Sent: 21 August 2025 14:56
[redacted]
Subject: RE: Planning consultation notification 25/01053/HHFUL

Planning Ref: 25/01053/HHFUL
Env Health Ref: 411991

8 The Paddocks, Hilton, Huntingdon PE28 9QT
Installation of stand alone air source heat pump to side

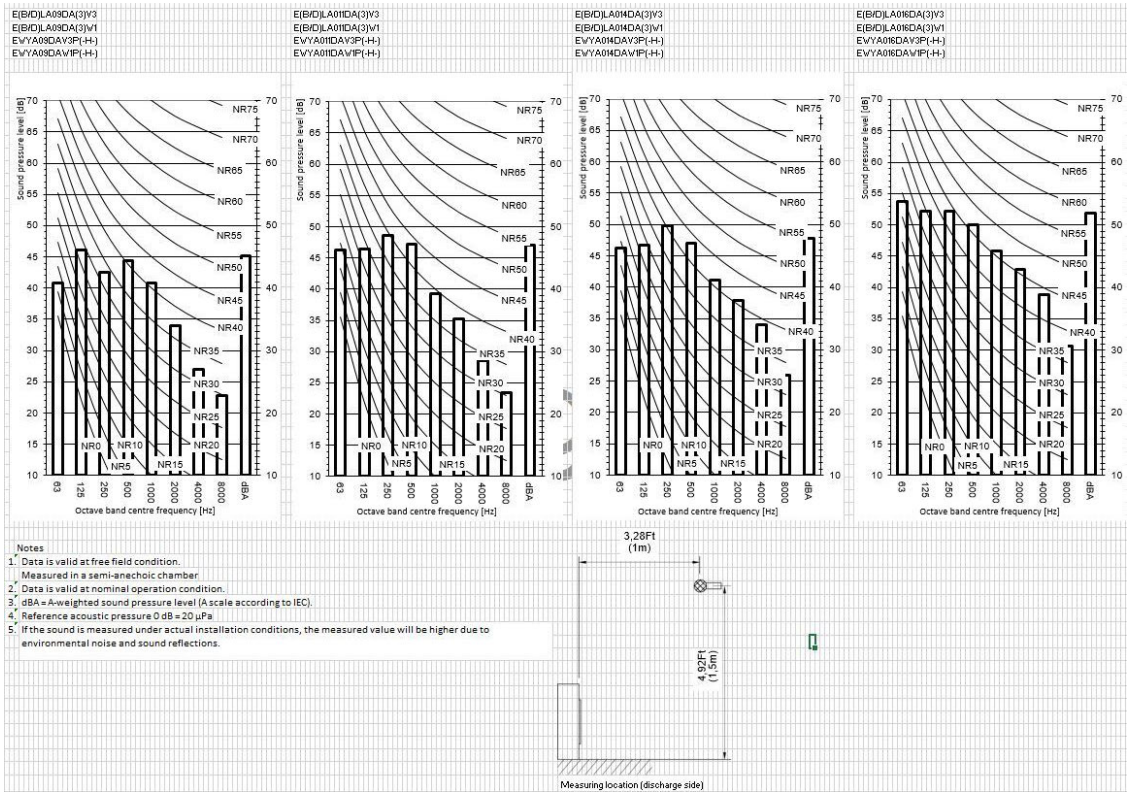
2. Tonality and Other Sound Characteristics
We have attached the octave band analysis for the EDLA16D3V37, which you are supplying to the council, to address your request for information on potentially distinctive sound characteristics such as tonality. The data, provided by Daikin, confirms that the unit does not exhibit any tonal characteristics.

A Microgeneration Certification Scheme (MCS) air source heat pump noise calculation has been undertaken and has shown that the predicted sound pressure level at the nearest noise sensitive receptor is likely to exceed the noise limit set out in the guidance. In this case, we would normally request a more detailed noise assessment and mitigation, however as this is a borderline case, we should first request further information about the ASHP.

The ASHP specification identifies one value; the sound power level of 62dBA during heating. This can often be misleading as it may not be expressed in accordance with a recognised test standard or relate to the noisiest operating mode, such as can occur during reverse cycles. Furthermore, information about potentially distinctive sound characteristics such as tonality or intermittency of operation have not been reported. This information should be provided before an informed decision can be made.

I have reviewed the extra information relating to the ashp and am now satisfied the sound level would be acceptable.

As you can see from the provided sound spectrum, the unit's noise is a broadband spectrum without any prominent peaks at specific frequencies. A tonal sound would appear as a significant spike (at least 5 dB above the average of the adjacent octave bands) within the spectrum. As the data clearly shows, this is not the case for our unit. This confirms that the sound output is consistent across frequencies and is not likely to be perceived as a distinct, annoying hum or whine.
